**N6774A-01**

**S E R V I C E N O T E**

**N6774A 300W DC Power Module**

**Current Measurement accuracy is out of specification when there is voltage being sourced at the output terminals.**

Location of C36 and C37

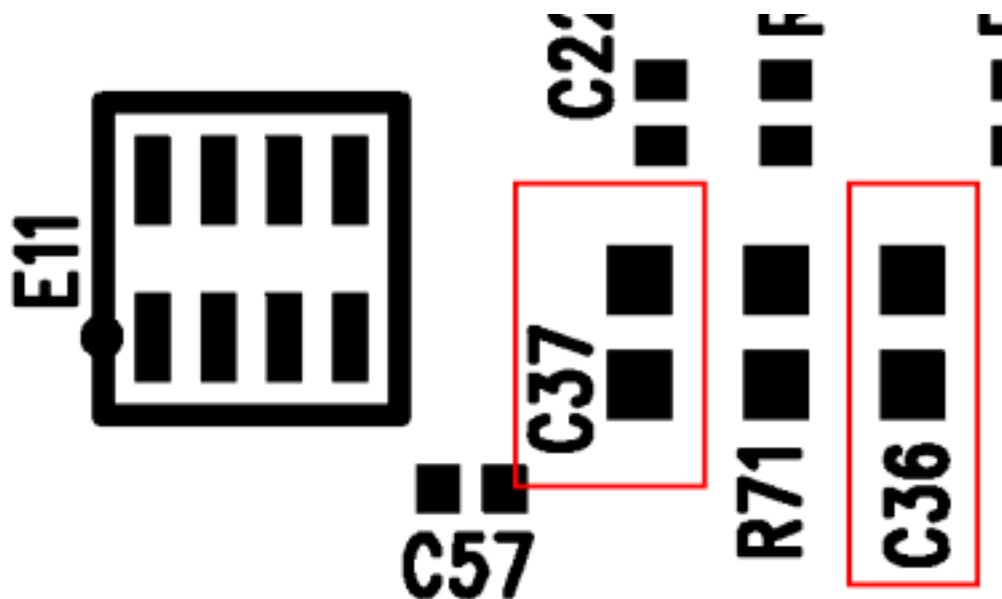
Due to some noise filtering issues, the current measurement accuracy will be out of specification by a fixed offset when there is a voltage being sourced at the output terminals. If the output is shorted, the current measurement accuracy will be within specifications. Please note that the performance verification test will not catch this.

Test to see if the module is out of specification by applying 75% of full scale voltage while drawing 50 to 70 mA . Compare the reading to what it should be via the current measurement accuracy spec. If the current measurement is within specification then the capacitors will not need to be changed.

If this measurement is out of specification, replace capacitors C36 and C37 on the DPM assembly (this is the assembly that is vertically mounted in the unit that looks similar to a PC memory module) with part number 0160-7809. After the capacitors are changed, the unit will require re-calibration. After the capacitors are replaced, check the make sure that the unit is in specification by applying 75% of the full voltage range while attached to a load drawing 50 mA to 70 mA. If the current measurement is within the specification, then the unit has been repaired.
